HISTORIC PRESERVATION COMMISSION

MARCH 25, 2021

A. COA 2021-00031

To: Historic Preservation Commission
From: Peter Hughes, Senior Planner
CC: Darryn Burich, Planning and Inspections Director
Kelly Brown, Administrative Specialist
Date: March 15, 2021
Subject: Major COA Request for 15 Carolina Vista

Proposed Elevation

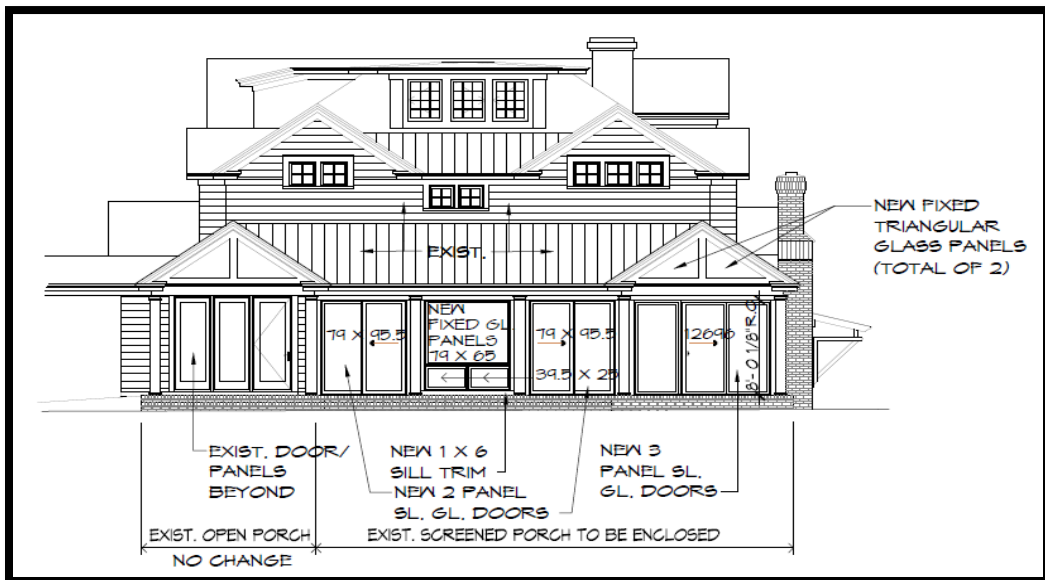
As stated above, the applicant is proposing to remove existing screening and add windows and doors sized to fit the existing openings. The replacement of the screening material with glass windows and doors should not compromise the architectural character of the structure. The addition of the windows and doors to the structure, transforms the space into a four seasons or Carolina room. Carolina rooms are common within the Historic District and the location of these changes are occurring on a rear elevation.

Submitted Site Plan

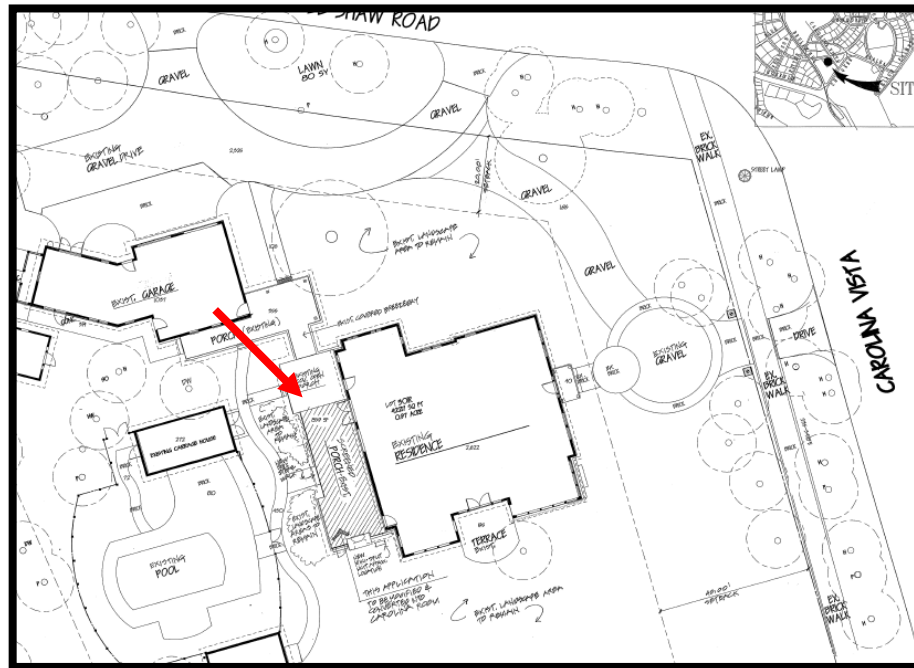
The doors are not street facing.

Proposed Rear Addition Elevation

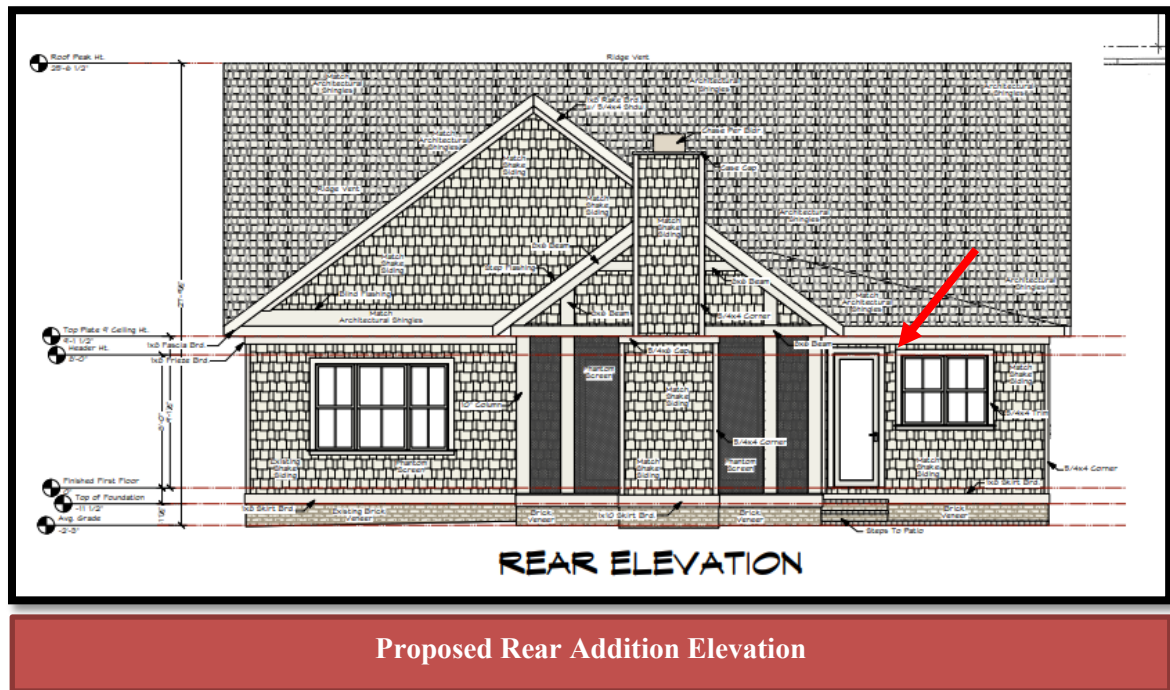
The submitted elevations of the proposed addition appear to indicate that roof forms of both the new porch and kitchen addition will be compatible with the existing roof forms.

Based on the submitted elevations one new door and one set of windows are to be added to the structure. The proposed door and windows appear to be compatible with the existing and proposed architecture. The windows match the existing grill pattern and the door also appears to line up with the headers or adjacent windows.

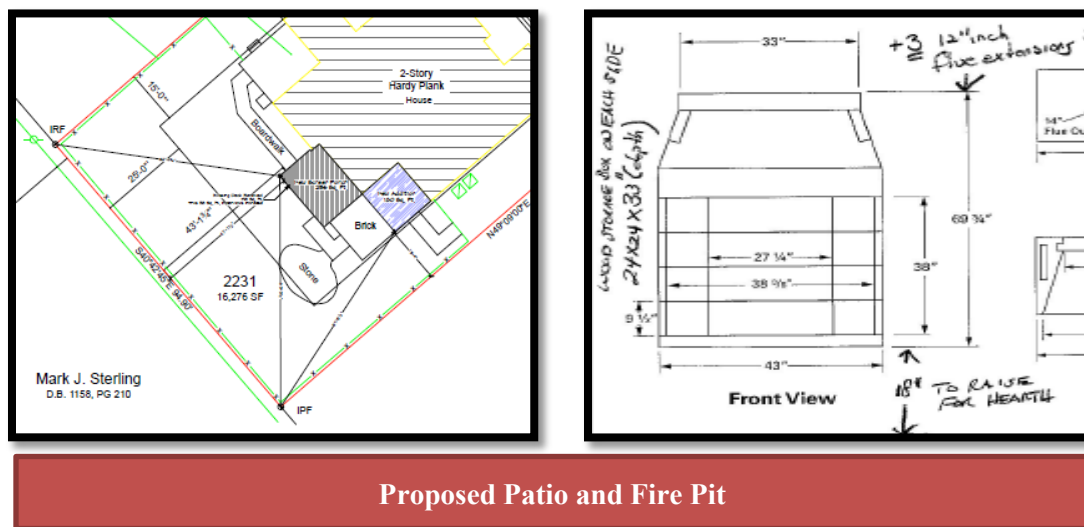
The chimney depicted in the elevation is boxed, however the applicant has indicated that it will be stone. The chimney if approved would not be visible from the street based on the proposed rear location.

No coatings or paint have been proposed for the chimney.

Existing Elevation and Previously Approved Rear Elevation

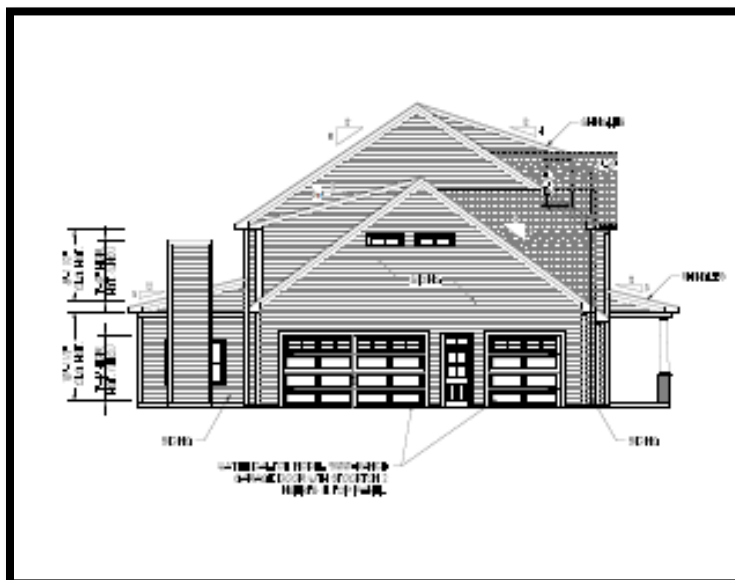
The sliding glass doors are located on the rear elevation.

Update Left Elevation

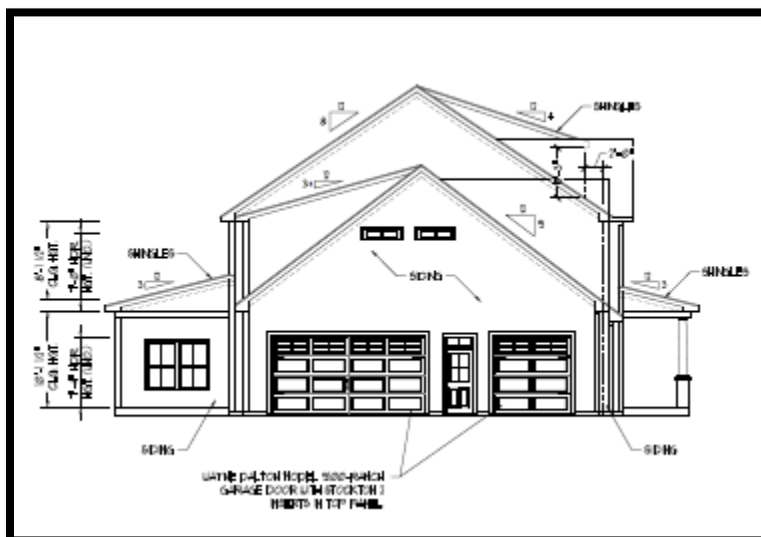
As a result of the chimney addition a window was not constructed as proposed on the left elevation of the structure.
